# CATHERINE FIELD (PART) PRECINCT PEER REVIEW WATER CYCLE MANAGEMENT & FLOODING

Prepared for:  
**DEPARTMENT OF PLANNING &  
INFRASTRUCTURE**

March, 2013

Prepared by:  
**J. WYNDHAM PRINCE**  
CONSULTING CIVIL INFRASTRUCTURE ENGINEERS  
& PROJECT MANAGERS

**100 Year ARI Difference Map  
Brown Developed - WMA Water  
Existing**

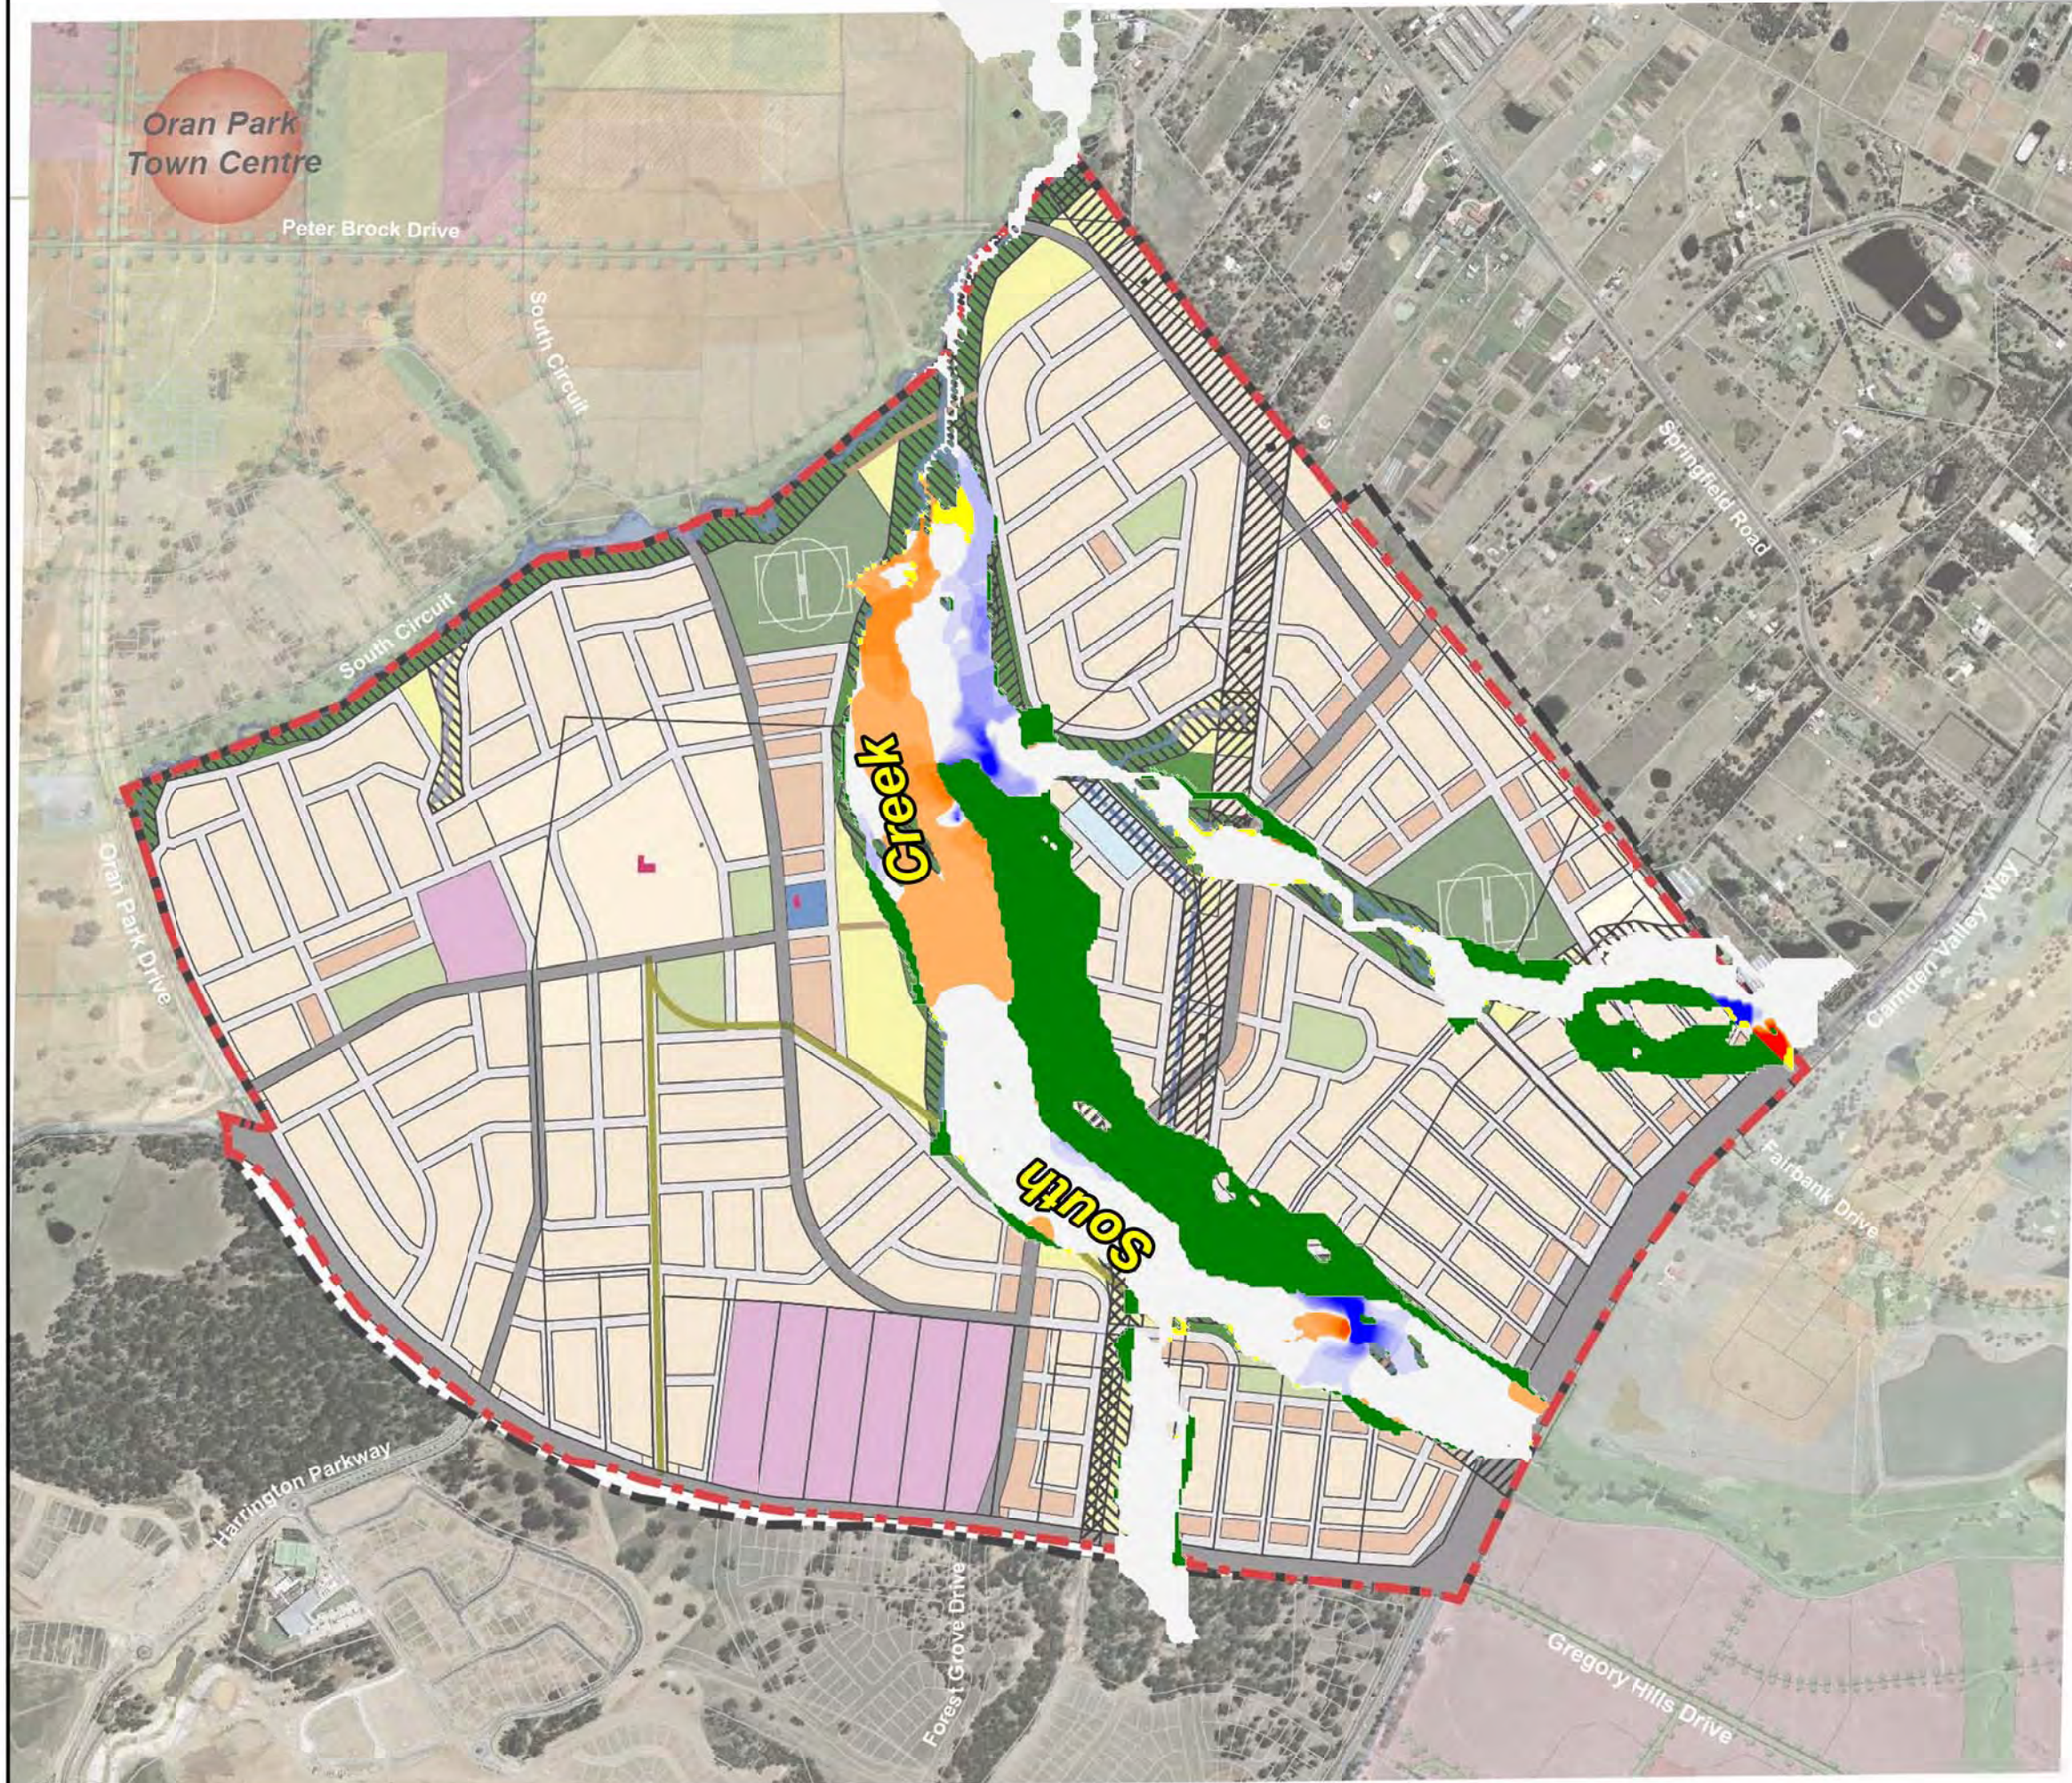
A comparison of the Brown developed 100 year ARI case flood levels with the existing WMA Water levels (Figure 3) shows the majority of flood levels for the Brown modelling are the same or less than the WMA Water flood levels. There are some isolated areas where the Brown flood levels are higher. The Brown Consulting developed 100 year ARI flood levels are up to approximately 780mm lower in areas and up to approximately 230mm higher in other areas. The difference mapping for this scenario also shows some increases in flood levels outside of the Precinct boundary.
